PLANNING COMMISSION AGENDA

Title: Final Site Plan - Canyon Point In Centerville, 347 N 400 E - ADMINISTRATIVE DECISION

**PLANNING STAFF REPORT
AGENDA ITEM: 1**

Title: PUBLIC HEARING - Planned Development Overlay Amendment - Parrish Creek Business Park 1160 N 950 W - Tom Stuart Construction - LEGISLATIVE DECISION

**PARRISH CREEK - BUILDING B
OVERALL LANDSCAPE PLAN**
1050 NORTH 950 WEST CENTERVILLE, UTAH 84014

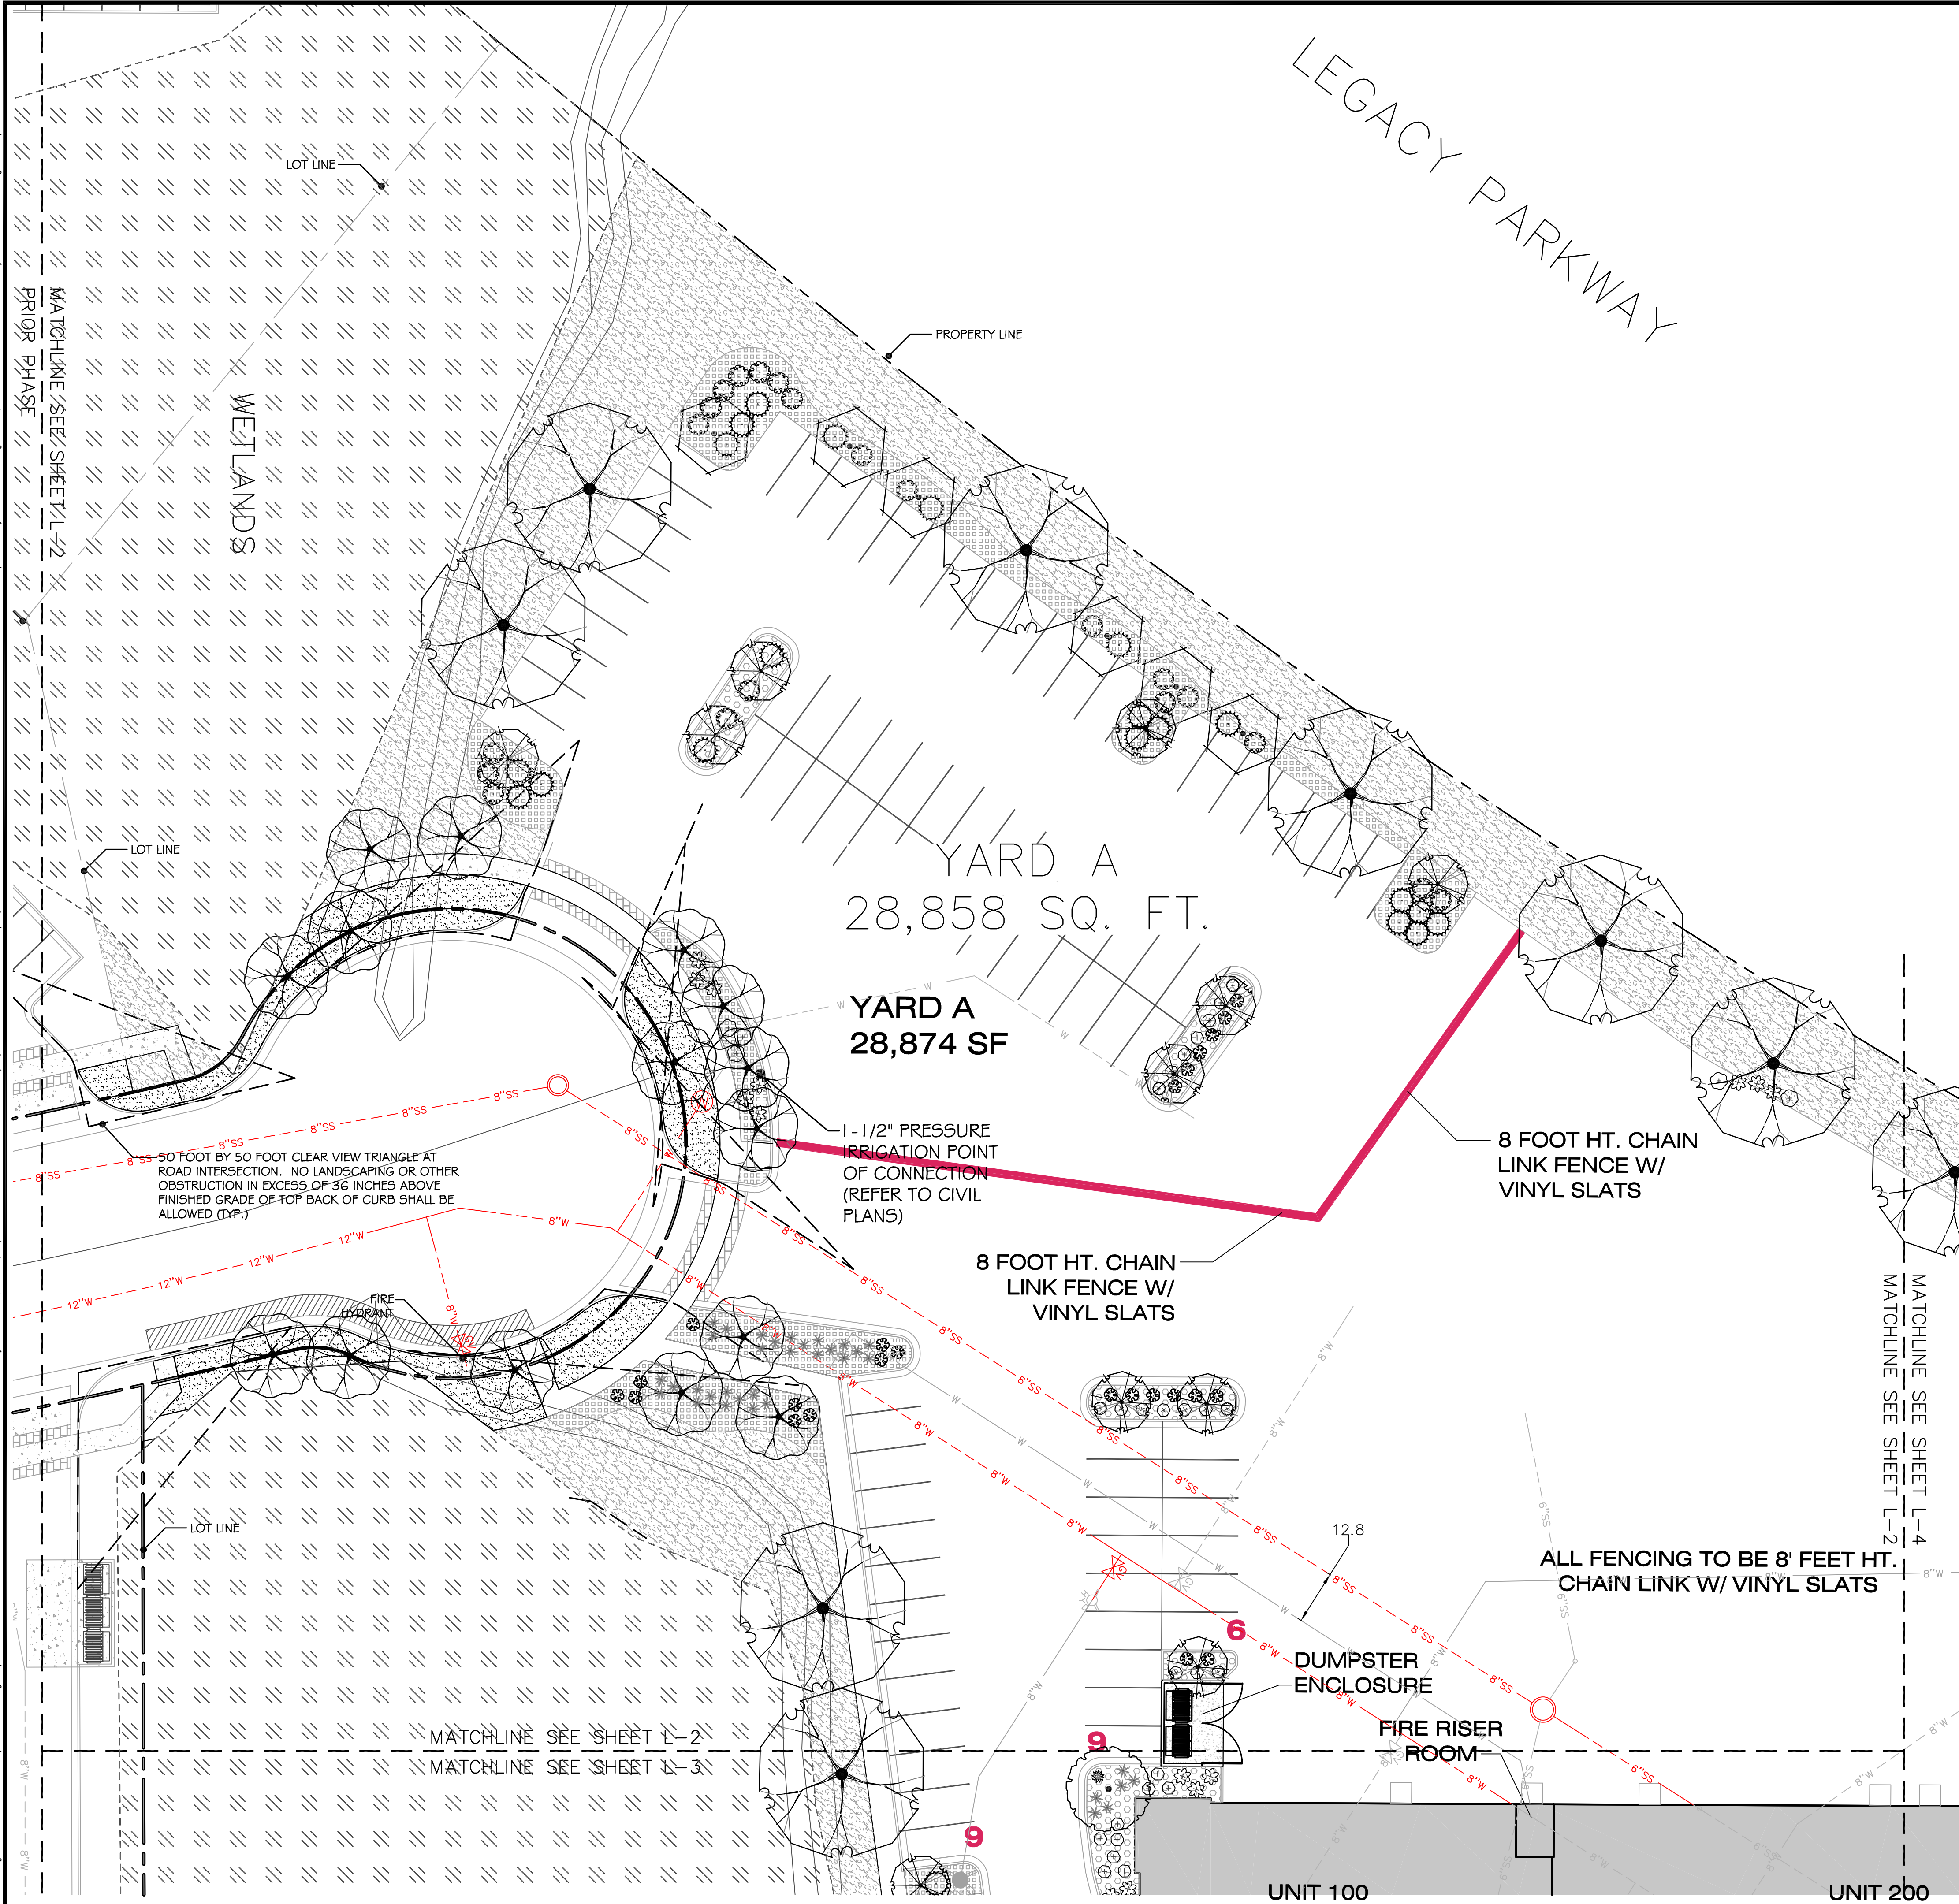
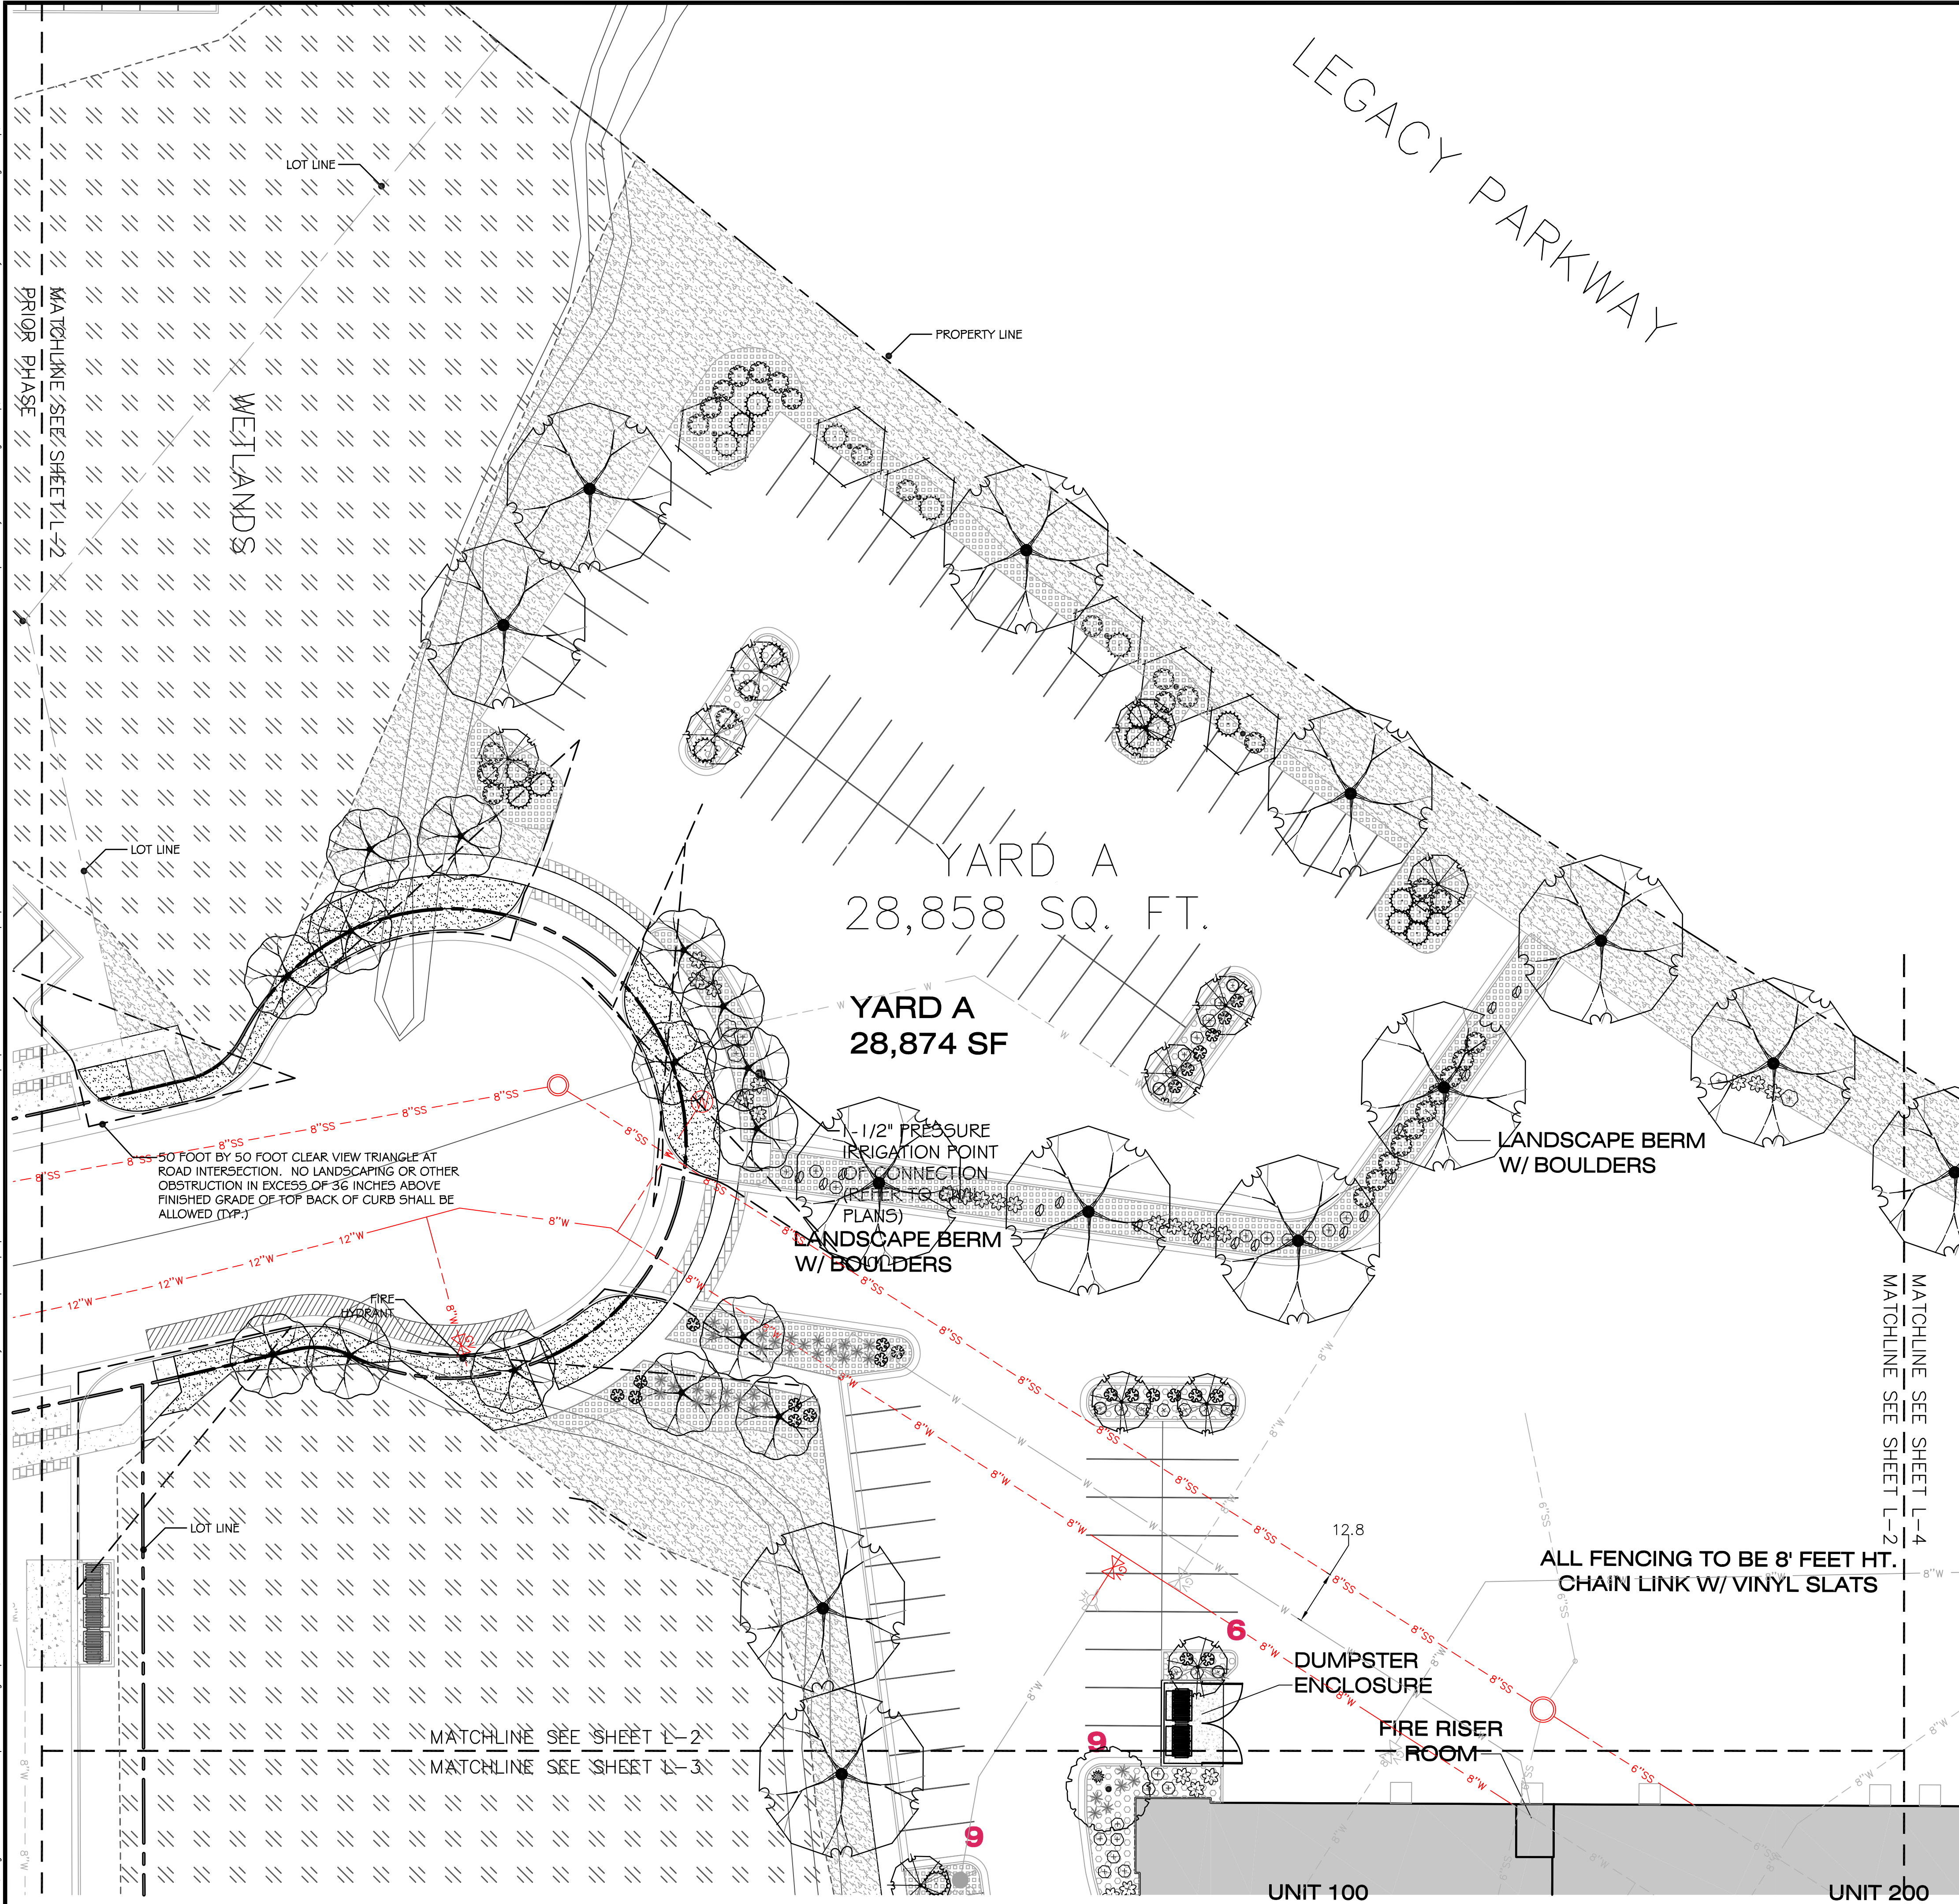
For both schemes, the plantings would remain the same. However, Option 1 is to install screened fencing around the yard area. Option 2 is to install a berm some additional landscaping to buffer the screening fencing along the northerly edge of the yard area. If yard area is generally acceptable to the Commission, the staff recommends that Option 2 with the berm and additional landscaping be the chosen scheme. Nonetheless, staff

- a. *Sheet AS.1 – Site Plan, dated June 30, 2022*
 - b. *Sheet L-1 through L-4 – Landscaping Plan with berm [i.e. Parrish Creek Building B - Proposal 2], dated June 30, 2022.*

- c. *The use of chain link fencing with slats shall be upgraded to a non-reflective coating with slats of a natural tone, consistent with the design of the SCP Zone across the Legacy Highway, as deemed acceptable by the approving authority at Final Site Plan Approval.*
